Diversified Metal Fabricators Service Bulletin SB 2062

Title	RW-1015 Locking Valve & Orifice Disc Interference
Document No.	SB2062
Issue Date	07/29/2011 (BJF)
Release	General
Units Affected	RW-1015 units manufactured between July 2010 & June 22nd, 2011
Purpose	Provide guidance on identifying and replacing leaking Locking Valve Cartridges

Figure 2: Hydraforce Locking Valve (Left) & Parker Locking Valve (Right)

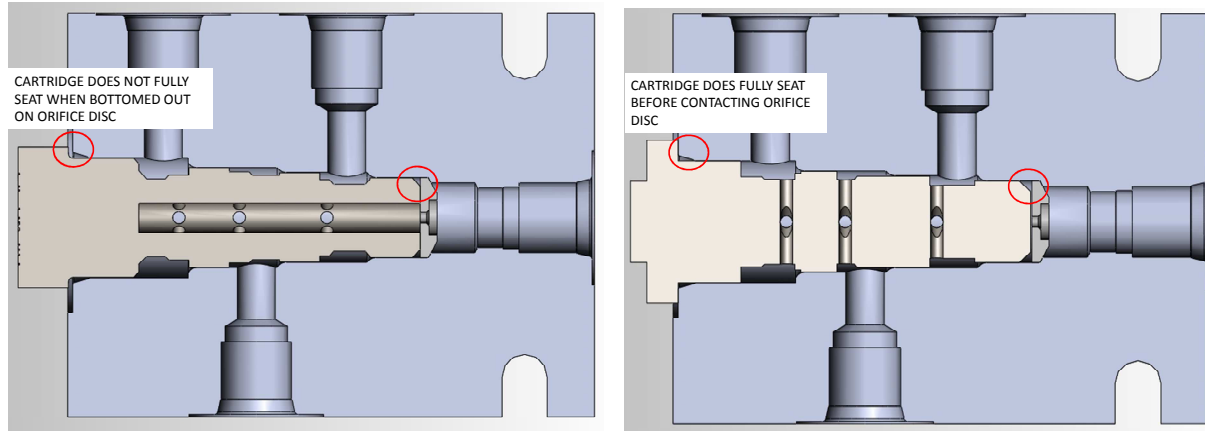
RW-1015 units with a Hydraforce locking valve (DC08-40), orifice disc, and Hydraforce manifold body (7024840) may leak down due to interference between the locking valve and orifice disc that prevents the cartridge from fully seating in the manifold body. The Parker locking valve (CPD084P) is shorter and will not interfere with the orifice disc.

RW-1015 units manufactured prior to July of 2010 did not include orifice discs from the factory but some units were retrofitted with orifice discs once in service (to eliminate Railgear stuttering during deployment). RW-1015 units manufactured between July of 2010 and June 22nd of 2011 were built with Hydraforce locking valves and orifice discs. These units may have an external leak or an internal leak that prevents the Railgear from holding its stowed position. See Figure 2 for an illustration of the interference.

The Parker locking valve is DMF part number 241016 (Parker # CPD084P). The .070" orifice disc used on RW-1015 is DMF part number 600613. Please have your DMF Railgear serial number and vehicle unit number ready when ordering parts.

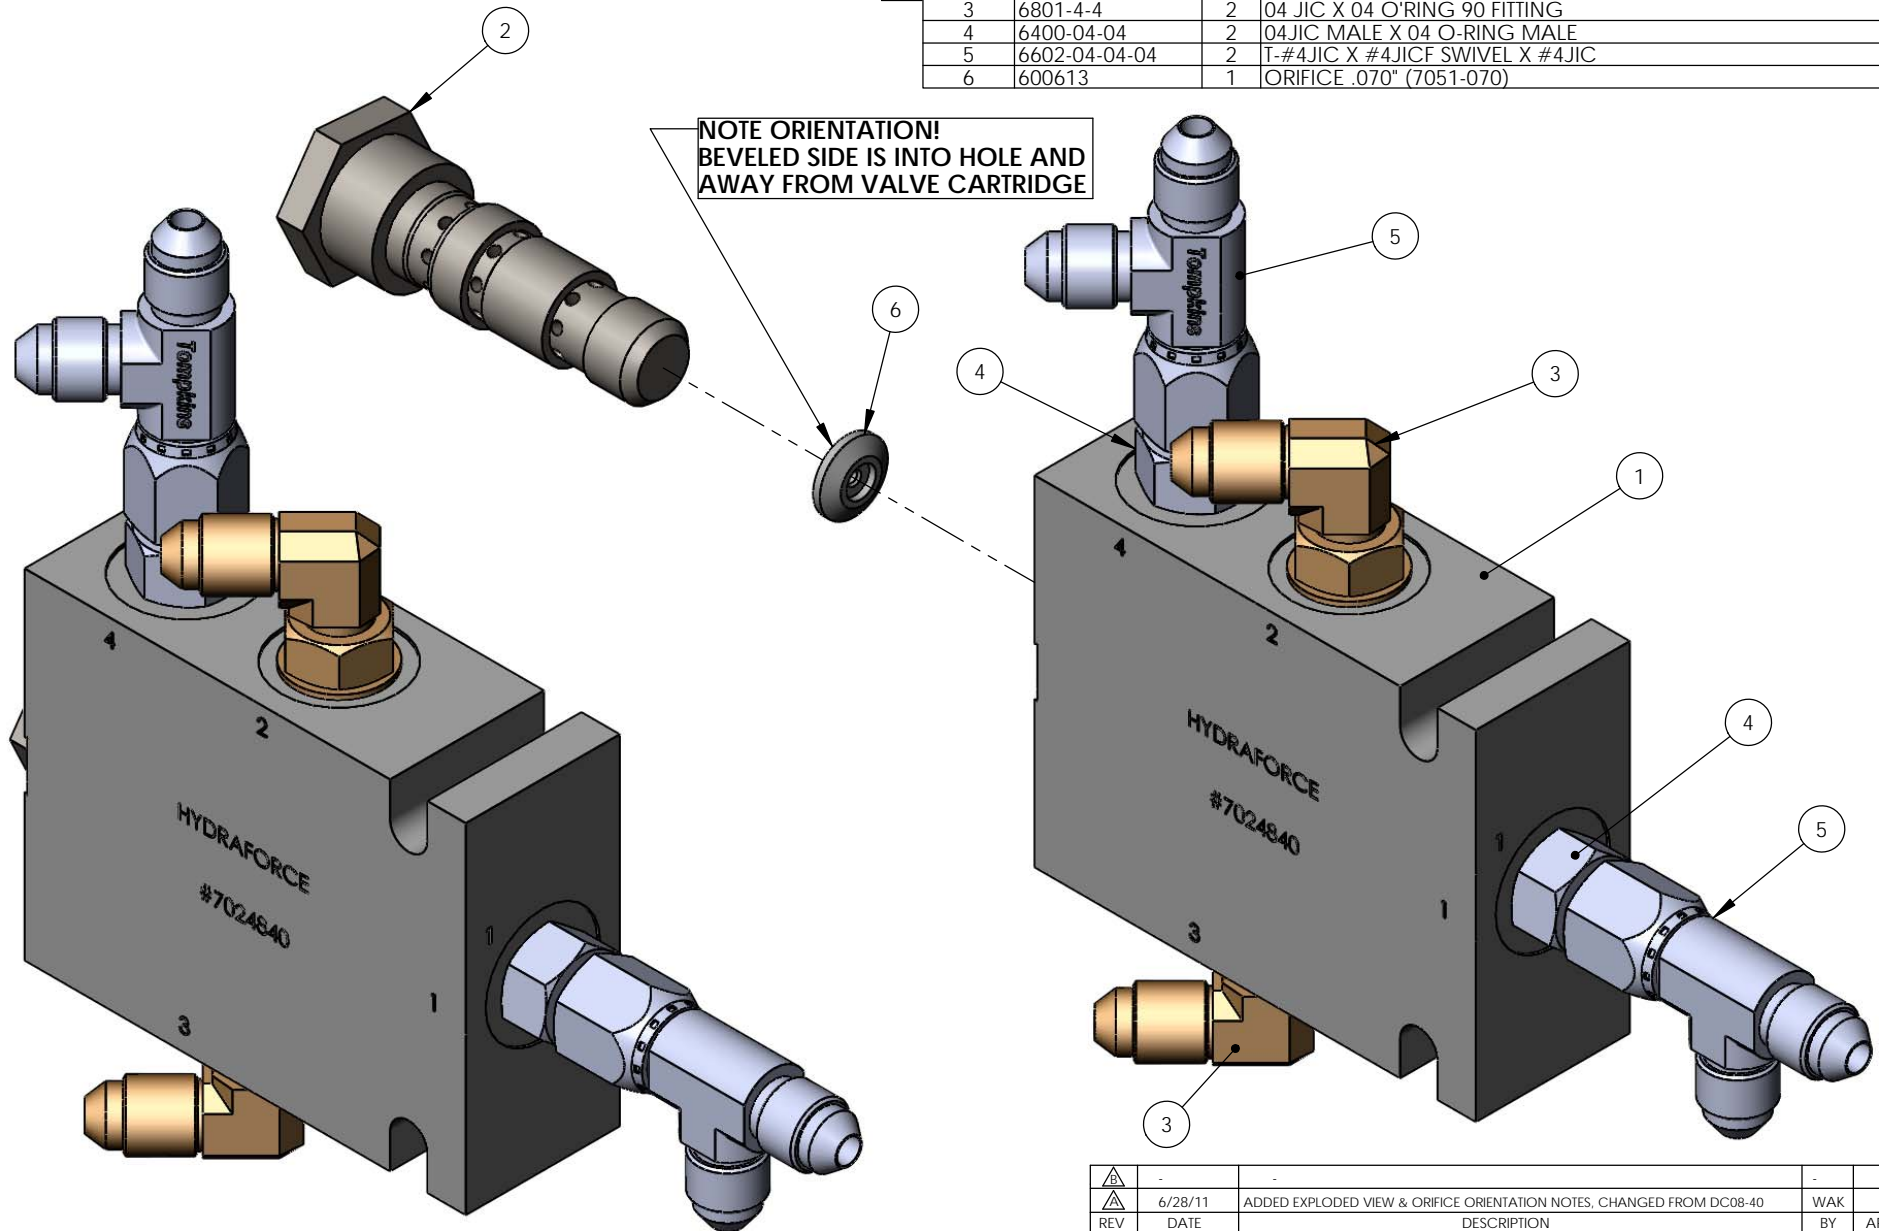
NOTE ORIENTATION!
BEVELED SIDE IS INTO HOLE AND AWAY FROM VALVE CARTRIDGE

△	-	-	-
△	6/28/11	ADDED EXPLODED VIEW & ORIFICE ORIENTATION NOTES, CHANGED FROM DC08-40	WAK
REV	DATE	DESCRIPTION	BY APP
TOLERANCES: (UNLESS SPECIFIED)		TITLE:	
FRAC. MACH:	± 1/32"	RW-1015	
FRAC. OTHER:	± 1/16"		
.XX	± .063	LOCKING VALVE W/ ORIFICE & FITTINGS	
.XX	± .030		
.XXX	± .005	DIVERSIFIED METAL FABRICATORS, INC. (404) 875-1512	
DRILL SIZES:	± .015	DRAWN BY:	APPD BY:
ANGULAR:	± 1°	JBG	
SURF FINISH:	125 MICRO	DATE:	8/19/2010
THREADS:	2A AND 2B	DRAWING NUMBER:	600611
<small>© 2011 DIVERSIFIED METAL FABRICATORS, INC. (404) 875-1512</small>			REV: A
